YARRA CITY COUNCIL
Internal Development Approvals Committee
Agenda

1.1 PLN16/1116 - 341-347 George Street, Fitzroy - Part demolition for the construction of a mixed-use building and a reduction in the car parking requirements

1. This report provides Council with an assessment of Planning Permit Application PLN16/1116 which affects the land at No's 341-347 George Street, Fitzroy. The application is for part demolition for the construction of a mixed-use building and a reduction in the car parking requirements.

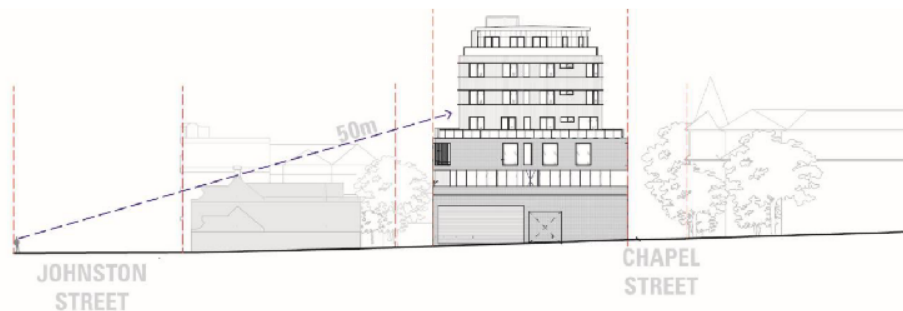
The DDO10 contains a discretionary maximum height of 4 to 6 storeys, with built form to be setback to meet various discretionary view line and amenity tests. The proposal at 7 storeys exceeds this preferred height by 1 storey. Therefore, relevant to the proposal, upper forms should avoid increased overshadowing of street and public space between 10am and 2pm at the equinox and minimise visual intrusion of upper levels when view from footpaths and public spaces.

The existing building, as demonstrated by the shadow diagrams, already significantly overshadows Chapel Street, between 10am and 2pm at the equinox. However, there appears to be an error in relation to the extent of existing shadows at 1pm and 2pm. Irrespectively, the existing building (which is largely proposed to be retained) already overshadows Chapel Street.

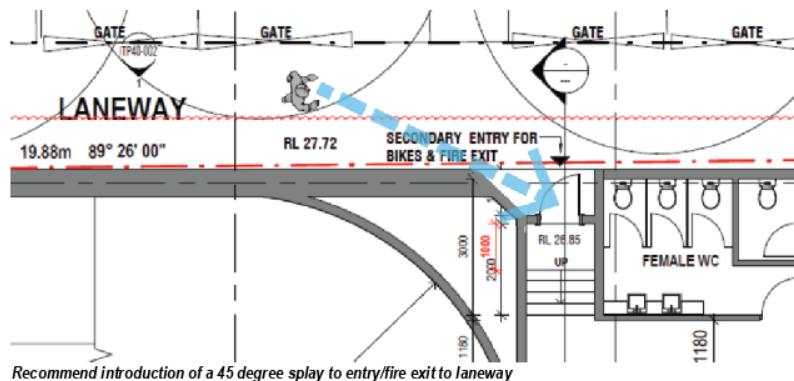
We are generally supportive of the overall site planning and make the following comments:

- We are supportive of the provision and extent of active frontage provided at ground level with frontage to George Street and wrapping the corner into Chapel Street. These tenancies are highly glazed and will provide appropriate engagement and activation of the street at ground level. The main building entrance is appropriately integrated into the heritage fabric and provides an appropriate 'sense of address' to George Street.

- The core is well located and responds to the site's stepped northern boundary by allowing an efficient basement layout, a large and flexible retail tenancy at ground and is concealed within the form at all upper levels.

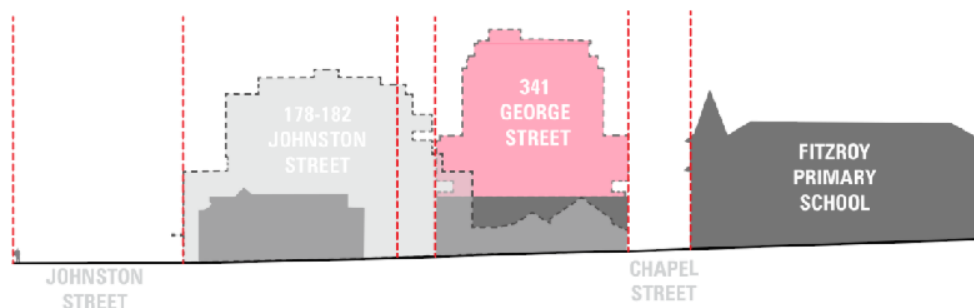
We note, the nearby approval at 178-182 Johnston Street is 7 storeys or 21.75m (RL 48.49) above Johnston Street. The proposal also rising to 7 storeys or approximately 26m (RL 53.30) above Johnston Street. While, the difference in overall height is noticeable, at approximately 4.81m, we consider it to be proportionate to the larger size as well as its position further away from Johnston Street. However, the site's relationship to Chapel Street, and visual exposure from Johnston Street somewhat tempers the site's capacity for height.

The DDO10 contains a discretionary maximum height of 4 to 6 storeys, with built form to be setback to meet various discretionary view line and amenity tests. The proposal at 7 storeys exceeds this preferred height by 1 storey. Therefore, relevant to the proposal, upper forms should avoid increased overshadowing of street and public space between 10am and 2pm at the equinox and minimise visual intrusion of upper levels when view from footpaths and public spaces.

Proposed and potential future visual impact of proposal as viewed from far side of Johnston Street

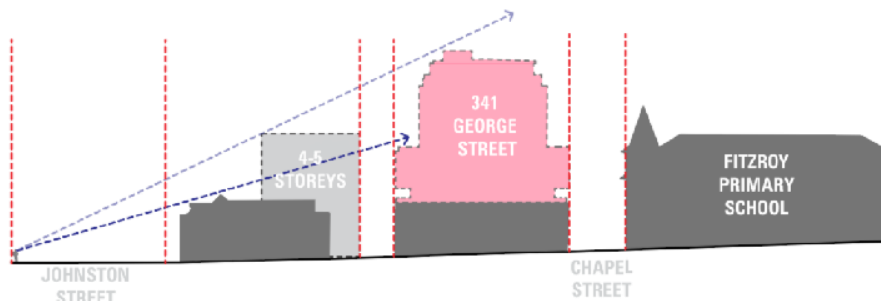
While, the subject site is situated behind a row of attached single storey terrace housing with a pitched roof and the 2 storey Rochester Castle Hotel. These relatively low heritage forms allow the upper 4 levels of the proposal to be clearly visible from the northern (far) side of Johnston Street. We acknowledge that these individual dwellings are under a single ownership, which increases their potential to accommodate development in the future. Given, the need to appropriately respect the single storey heritage terraces, we envisage that a modest 4-5 storey form could be contemplated to the rear of these consolidated properties. If such a form were to exist (in the future) it would considerably conceal (or completely hide) the proposal from views from Johnston Street.

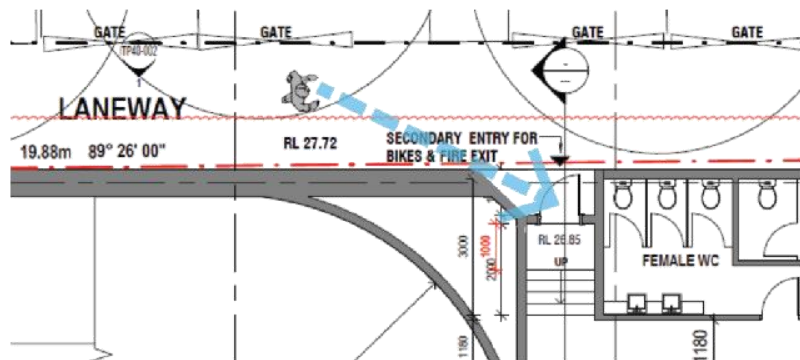
- Bicycle storage is provided at ground level, in a centrally located and convenient position. It also benefits from three points of access, either via the vehicle entry, through the front door or via a secondary entry to the laneway.
- In order to improve the safety of the laneway, we would recommend that a 45 degree splay be incorporated within the western wall of the secondary pedestrian entry/fire exit to enable sightlines into the recessed doorway (upon approach from Rochester Street).

Recommend introduction of a 45 degree splay to entry/fire exit to laneway
